87.8.11 -Stressed receiver sensitivity

87.8.11.1 Stressed receiver conformance test block diagram

Figure 87-2—Stressed receiver conformance test block diagram

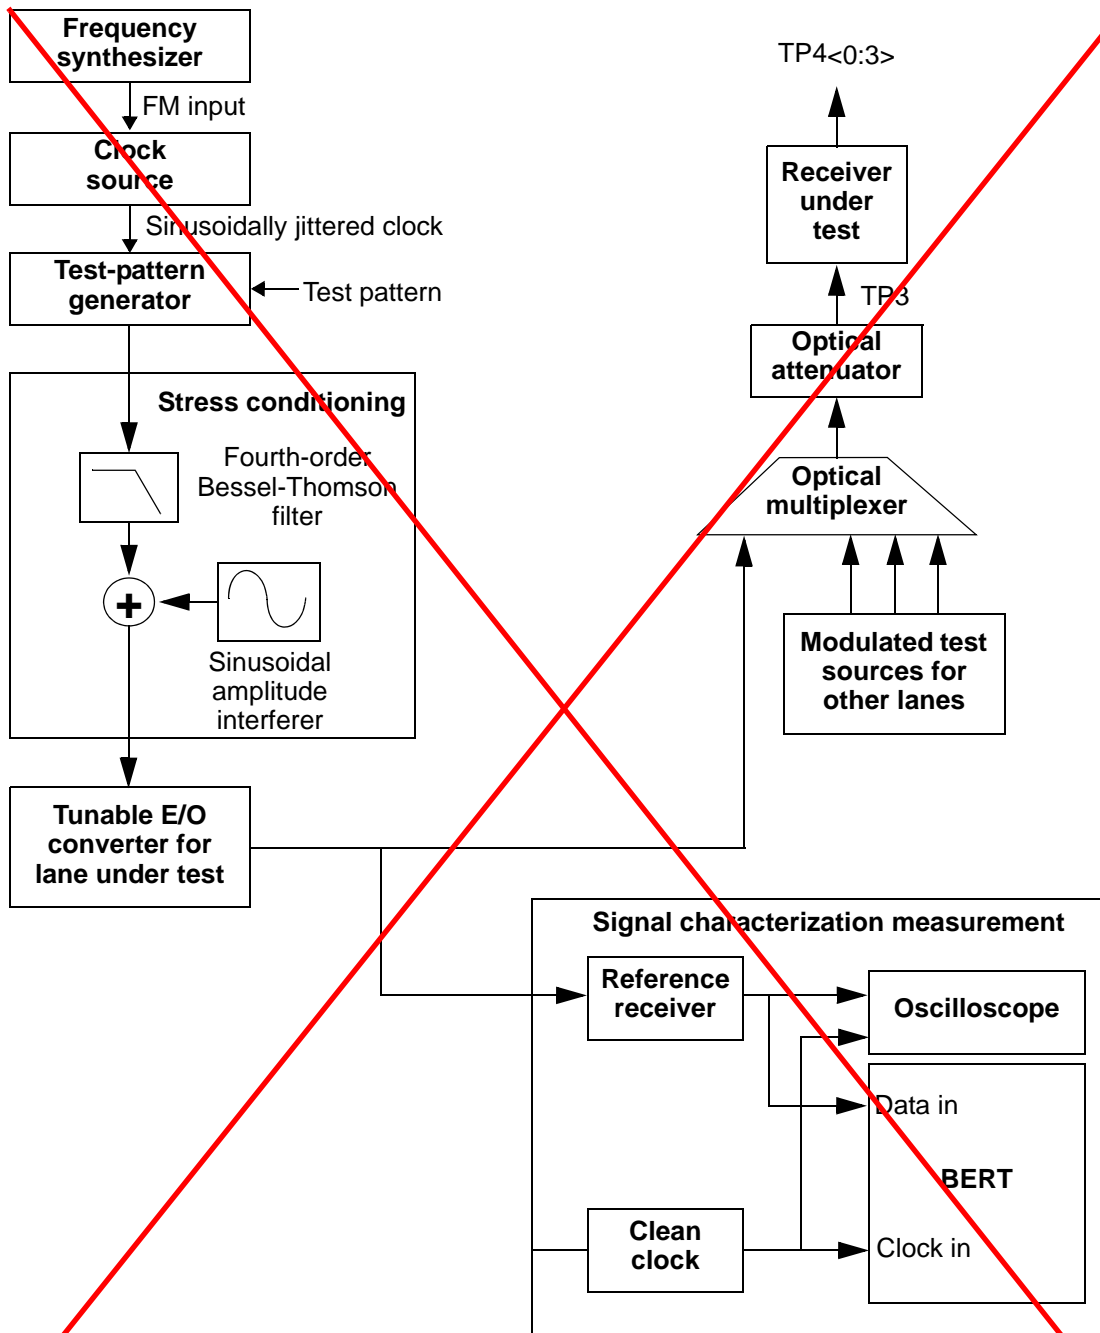
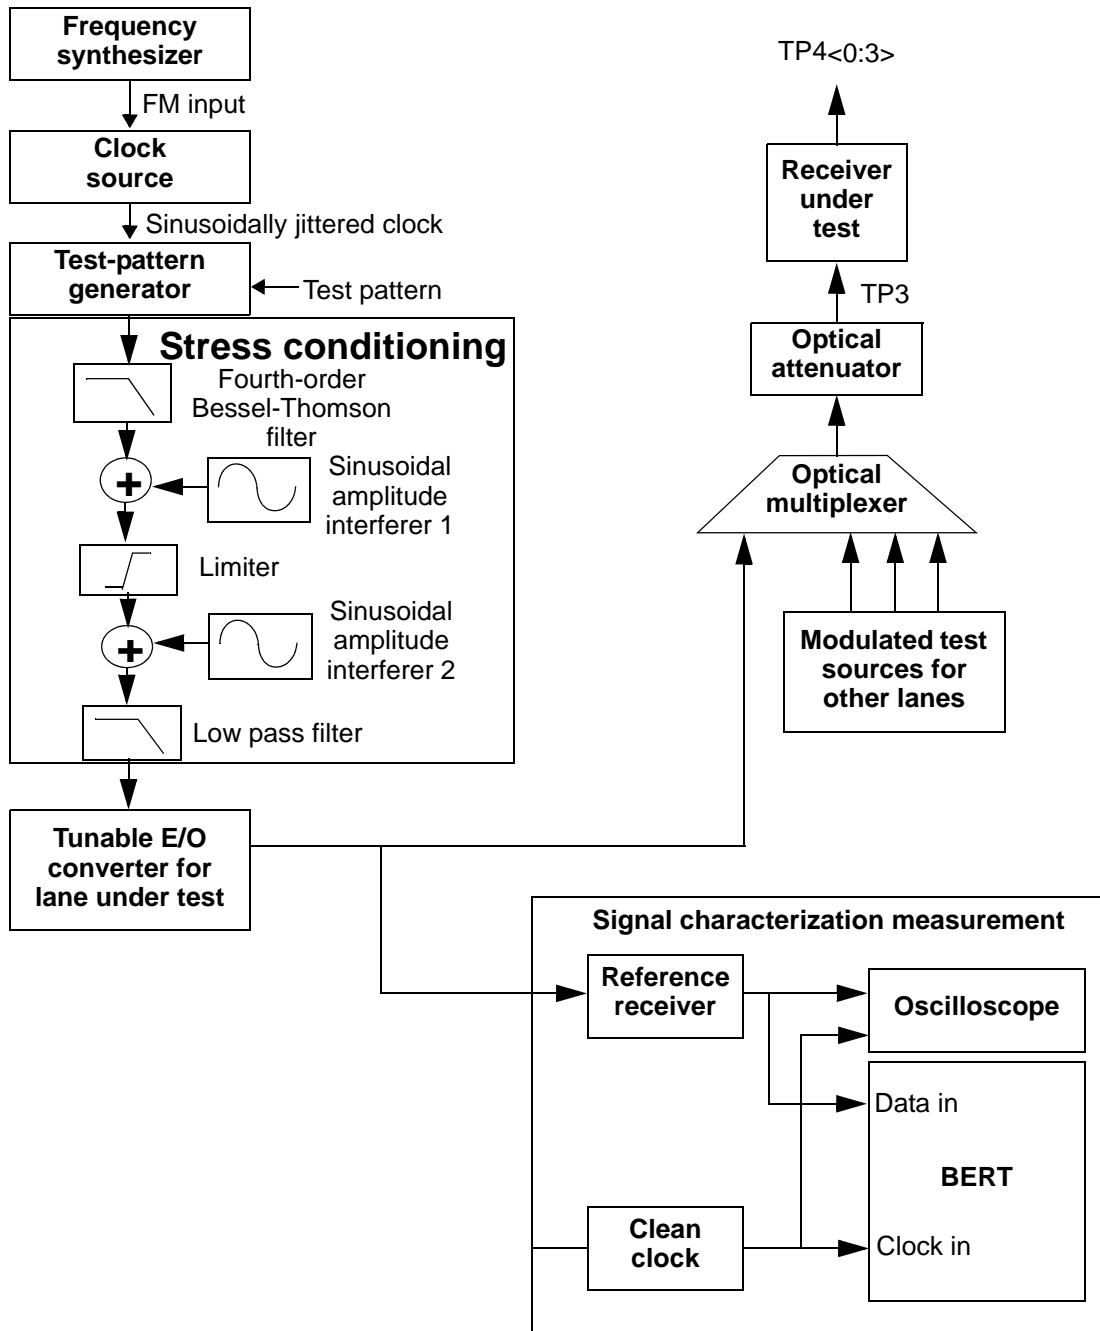
The ~~fourth-order Bessel-Thomson low pass~~ filter is used to create ISI-induced vertical eye closure penalty (VECP). The ~~Bessel-Thomson low pass~~ filter, when combined with the E/O converter, should have a frequency response which results in the appropriate level of initial vertical eye closure before the sinusoidal terms are added.

[An example stressed receiver conformance test set up is shown in Figure 87-2, however, any approach that modulates or creates the appropriate levels and frequencies of the jitter components is acceptable.](#)

Figure 87–2 shows the stress conditioned signal being applied to a tunable E-O convertor. However, any optical source may be used which can meet the OMA and wavelength requirements for the lane under test as described in . Similarly, the other test sources which supply modulated signals to the other lanes may use any tunable or fixed sources which meet the OMA and wavelength requirements described in .

Figure 87-5—Illustration of the mask of the sinusoidal component of jitter tolerance

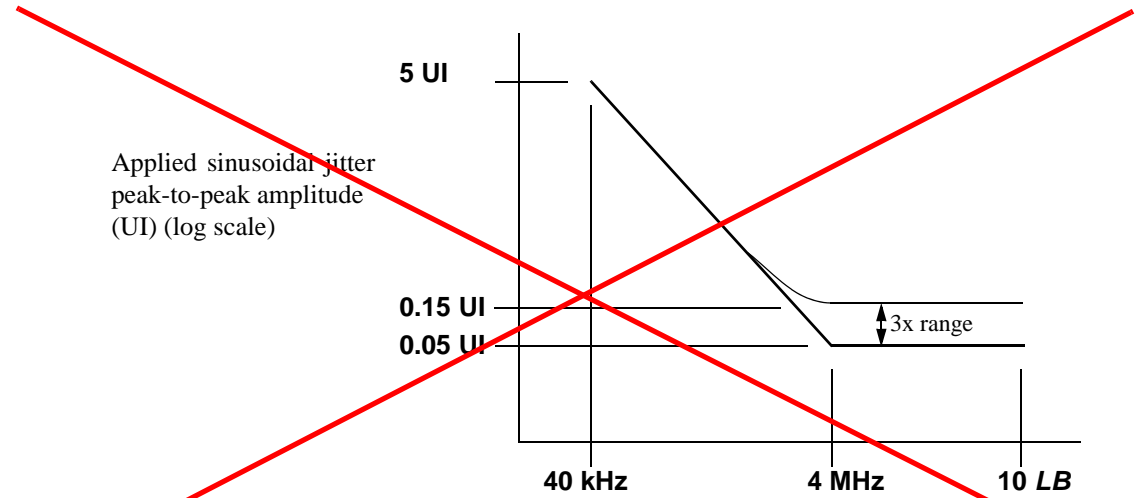
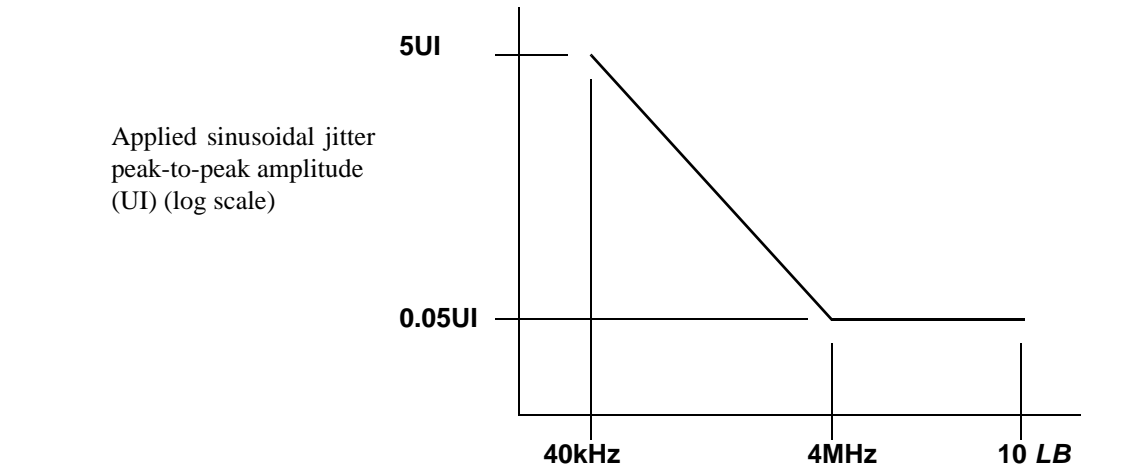
Frequency range	Sinusoidal jitter, peak to peak (UI)
$f < 40$ kHz	Not specified
40 kHz $< f \leq 4$ MHz	$2 \times 10^5 / f + S - 0.05^a$
4 MHz $< f < 10$ LB ^b	$0.05 \leq S \leq 0.15^a$ <u>05</u>

^a~~S is the magnitude of sine jitter actually used in the calibration of the stressed eye per the methods of 87.8.11.2.~~
